CORE

NOW CALLED PIC-1 (Being used over "CORE")

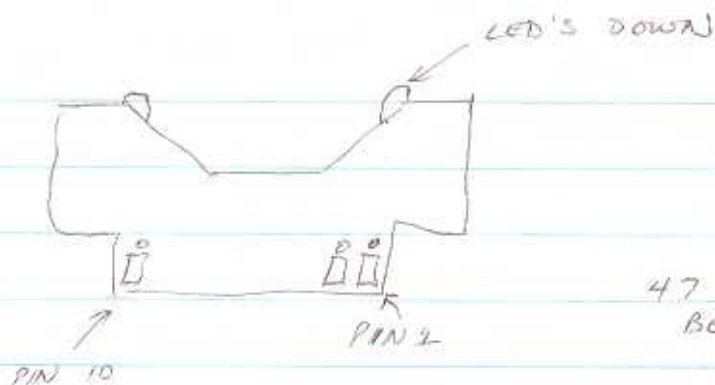
4.7 MICRO FARAD
BETWEEN PINS 2 & 10

This reduces the problem of CORE locking
up when dropped.

+ ON PIN 2, - ON 10

"TANTALUM" CAPACITOR
